### FAX COVER SHEET

FAX NUMBER TRANSMITTED TO: 225-925-4414  
 TO: Jim Waite  
 FROM: Chuck Dammon  
 CLIENT/MATTER: TEXTROW MARINE  
 REFERENCE: PO 333142 & PO334424  
 DATE: 12-6-07 NO. OF PAGES INCLUDING COVER SHEET: 4

**TEXTRON OFFICE PLAN**

TEXTRON  
MARINE AND  
LAND  
2585 FRONT ST.  
SLIDELL, LA.

SCALE: AS NOTED  
DATE: 9-5-07  
SHEET  
A-1

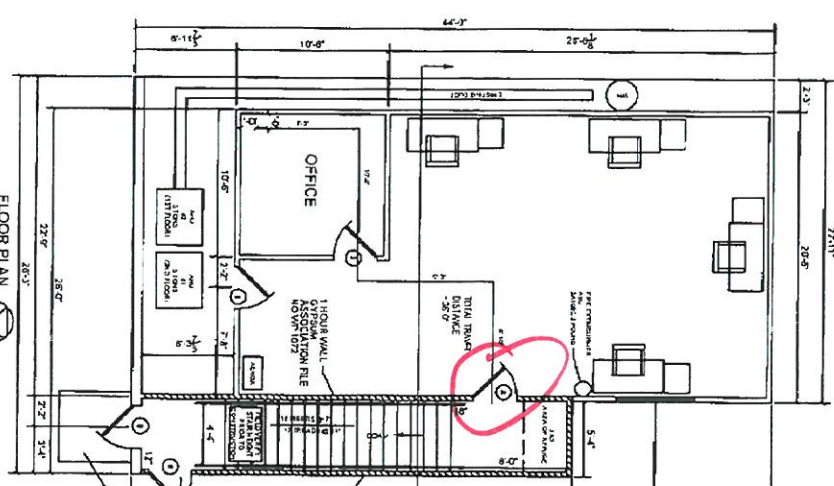
Chuck See NFPA 101: 7.2.1.4.3  
DOORS @ EXIT ENCLOSURES SHALL SWING IN  
the direction of egress.

WOOD STRUCTURAL PANELS  
shall be in accordance  
with section 603
